17 May 2021

RE: SUBMISSION | SSD-10464 AT 50-52 PHILIP STREET, SYDNEY

Figure 2. Dormer windows and decorative cast iron 'cresting'

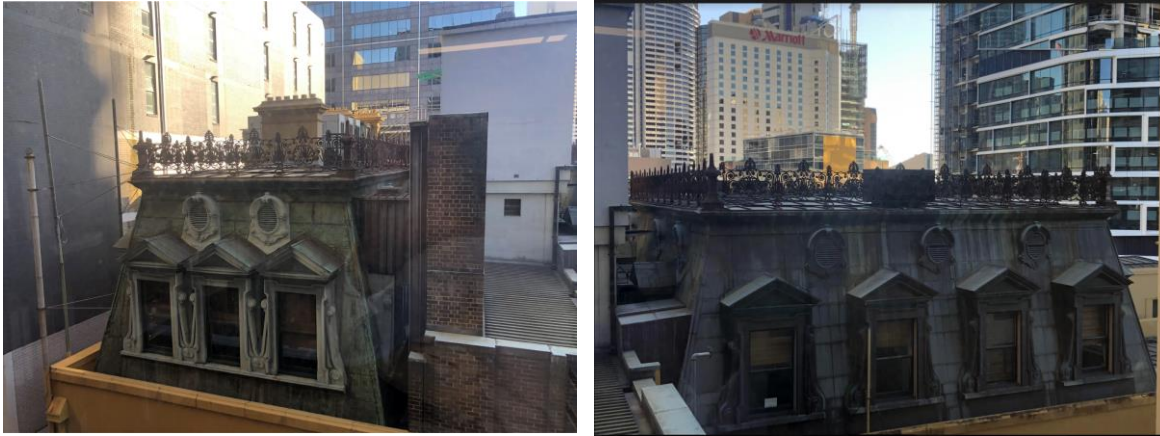
Tenants within the building at 127-131 Macquarie Street consider the mansard roof and dormer windows and the decorative cast iron 'cresting' to the roof gives the upper storeys a distinctly Parisian character and should be retained and restored. It appears this item is identified within the Heritage Conservation Management Plan as being of significance.

The Strata Plan support the full retention and restoration of these items of the heritage building at 50 Phillip Street.

- Support for the retention and restoration of the dormer windows and the decorative cast iron 'cresting' to the roof gives the upper storeys a distinctly Parisian character;
